Subject: **iBR Parts Substitution**

No. **2010-9**

YEAR	MODEL	MODEL NUMBER	SERIAL NUMBER
2009	GTX Limited iS	All	All
	RTX iS		
2010	GTX, GTX iS and GTX Limited iS		
	RTX, RTX iS, RTX-X and RXT-X RS		
	WAKE Pro

iBR Actuator and Fixing Plate

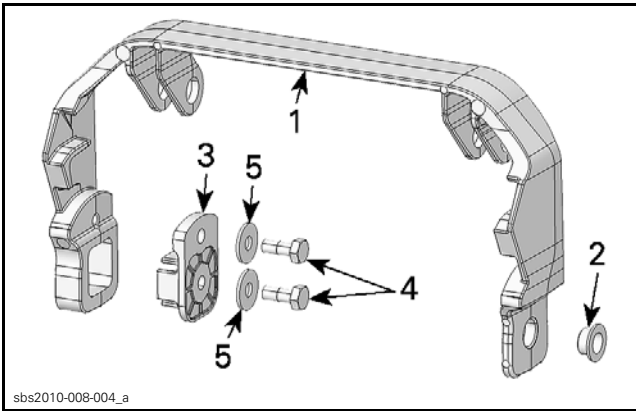
When ordering the 2009 or 2010 iBR actuators, it will automatically substitute to the 2011 version, along with the needed parts to install the new execution into the vehicle it was ordered for. This is a "bolt on" direct replacement.

To remove the iBR actuator and the fixing plate use the procedure described in the appropriate shop manual.

To install the new iBR actuator and the fixing plate use the procedure described in the appropriate shop manual.

U-arm

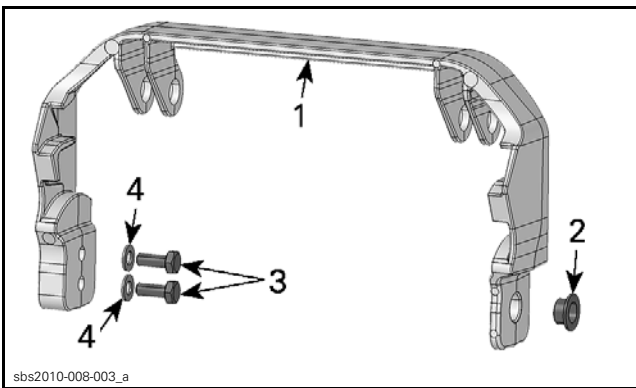
MY2009 and MY2010 Configuration

1. U-arm
2. Bushing
3. Locking sleeve (iBR key)
4. Retaining screws
5. Flat washers

New Configuration

1. New U-arm
2. New bushing
3. New M8 x 20 hexagonal flange screws
4. New M8 flat washers

Install the new provided bushing on the RH external side of the U-arm.

Secure U-arm to iBR actuator using new M8 x 20 hexagonal flange screws and new M8 flat washers.

U-arm retaining screws	24 N•m (18 lbf•ft) (Apply torque twice)
------------------------	--
